Department of Environmental Quality

November 12, 2025

Re: WQ: Variance Approval: 248-25-000274-VAR: 17043 Elsinore Road; T.20S; R.10E; Sec. 12D;
Tax Lot 200 & 300; 1.01 Acres; Deschutes County.

Variance Decision:

Figure 2. Site Plan

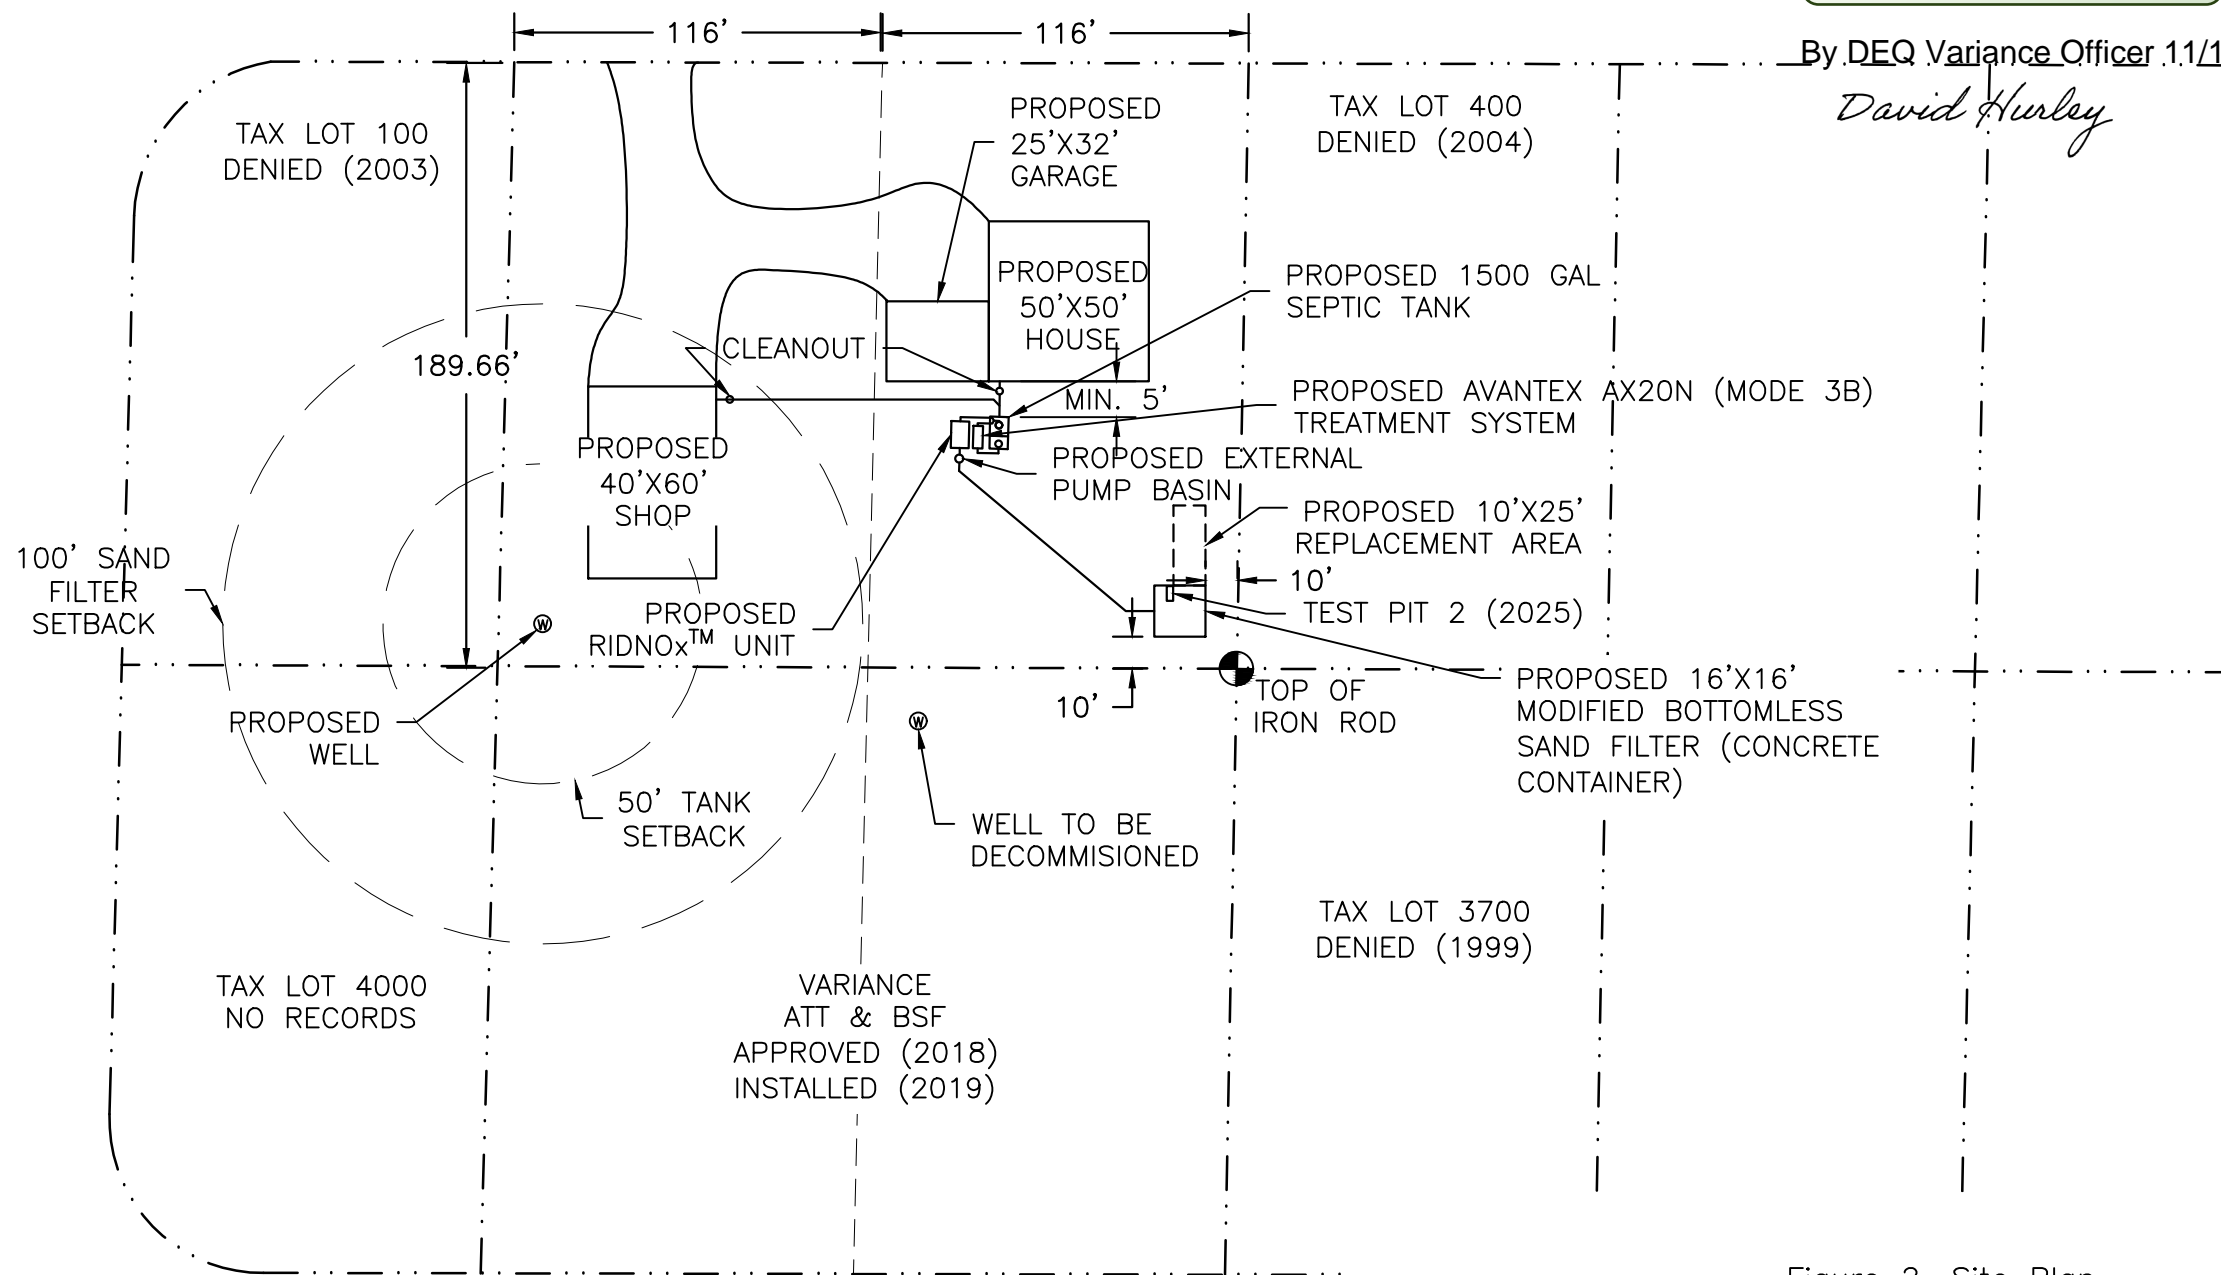
APPROVED

By DEQ Variance Officer 11/12/2025

Figure 3A. Modified Bottomless Sand Filter Section – Initial

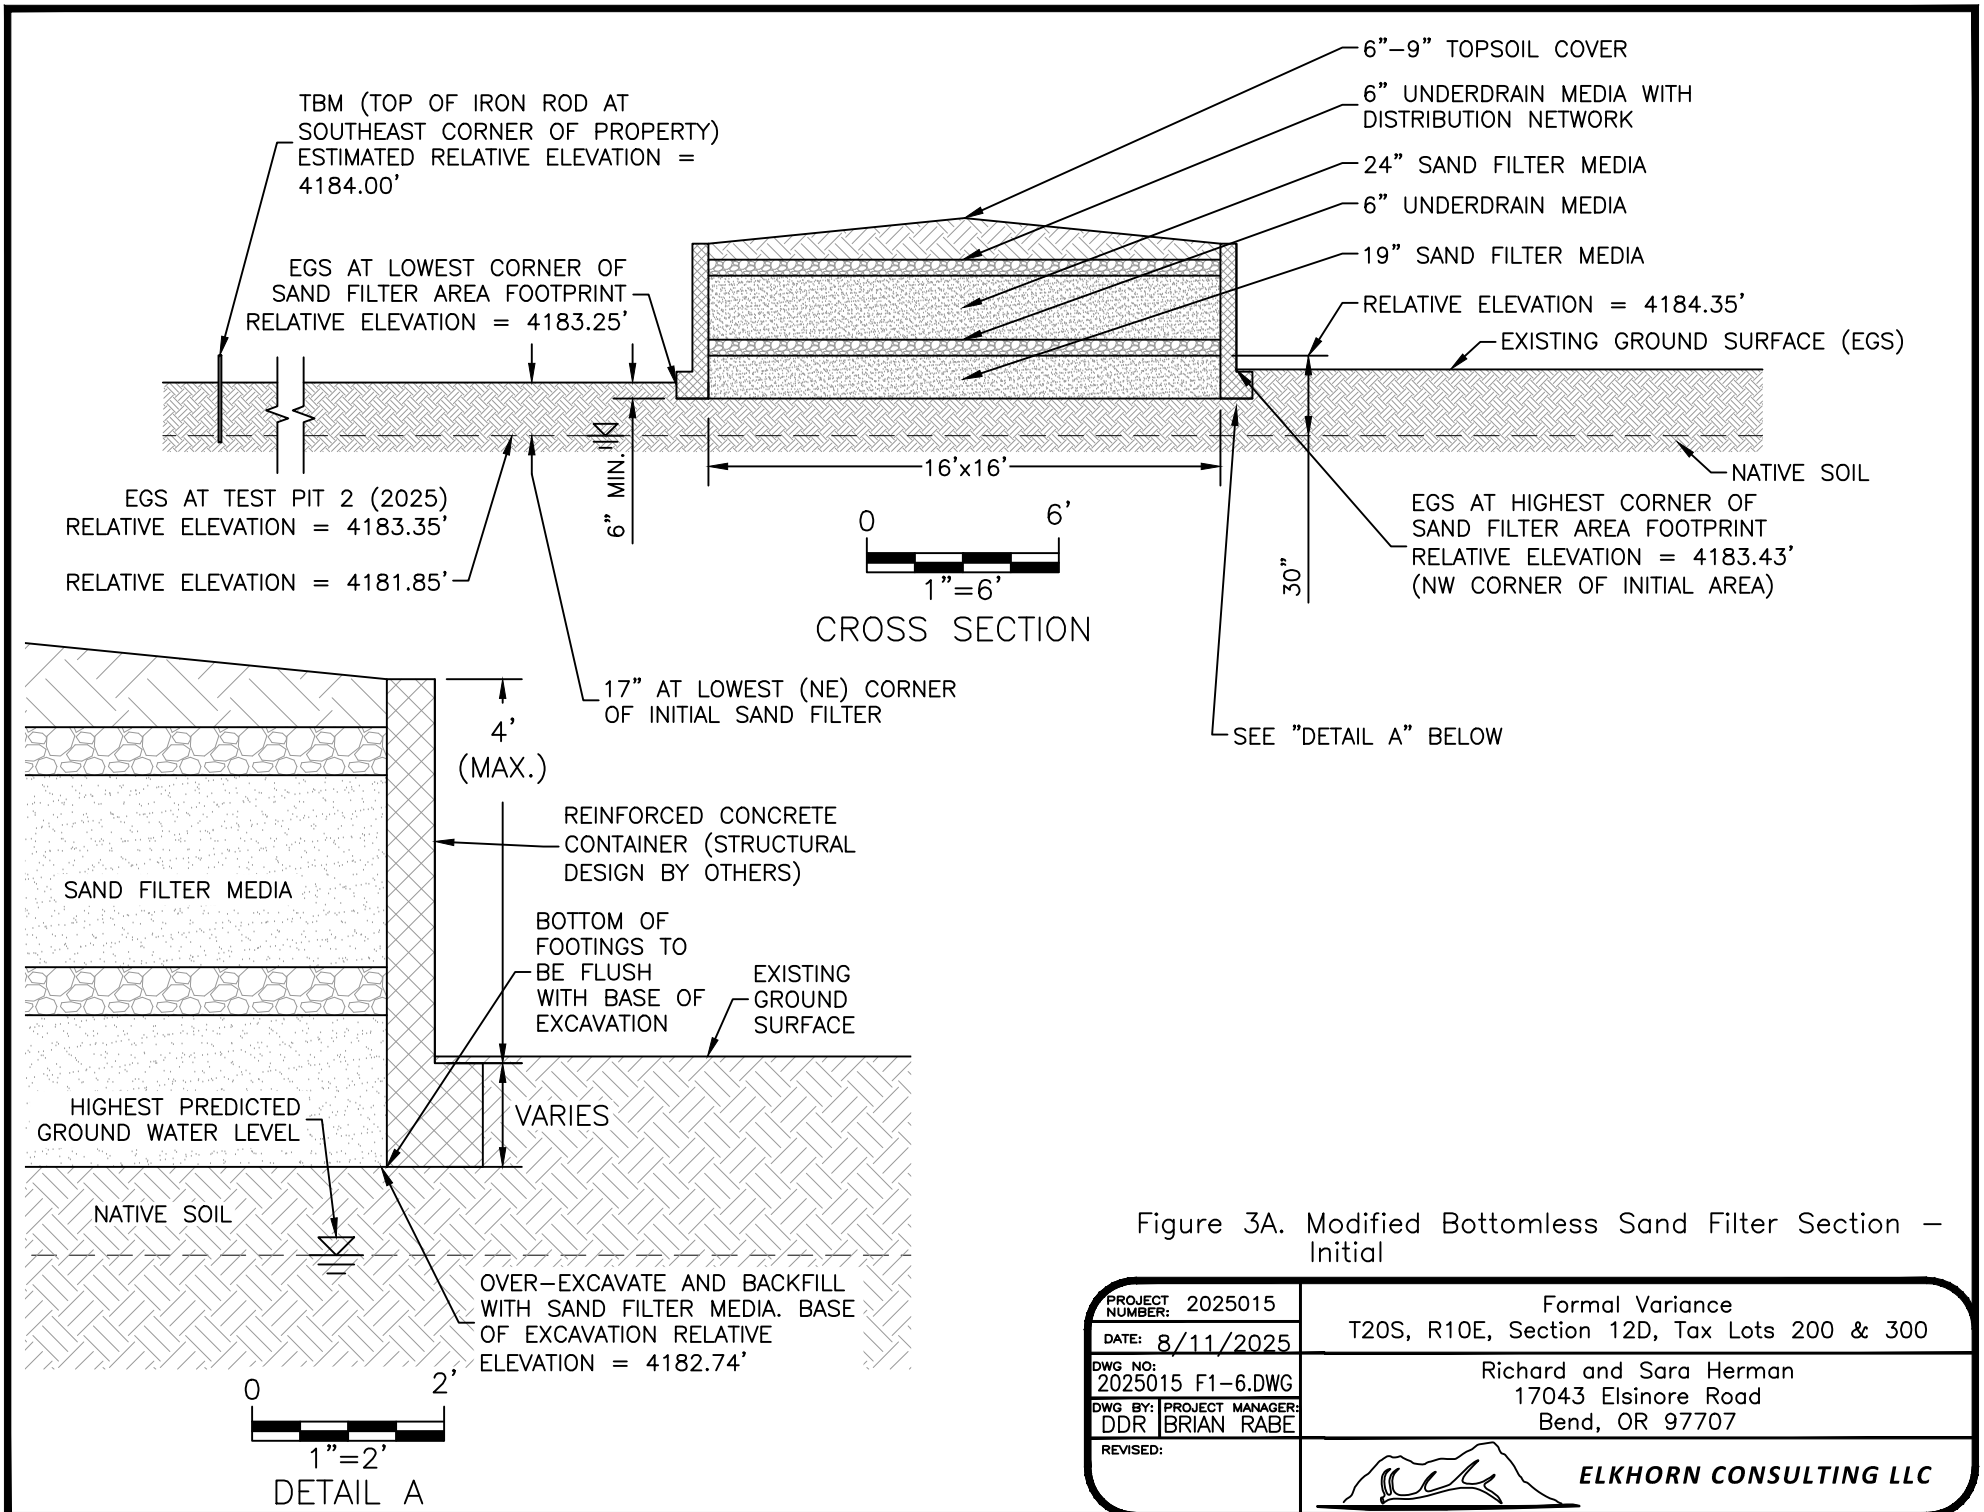
additional 13-inches of sand filter media (embedded 6-inches below ground surface) placed below the filter to meet or exceed the minimum 24-inch separation requirement to groundwater below. Note: The bottomless sand filter is assumed to meet Treatment Standard 2 criteria independently of the ATT, which is why UV disinfection is not included in the proposal.
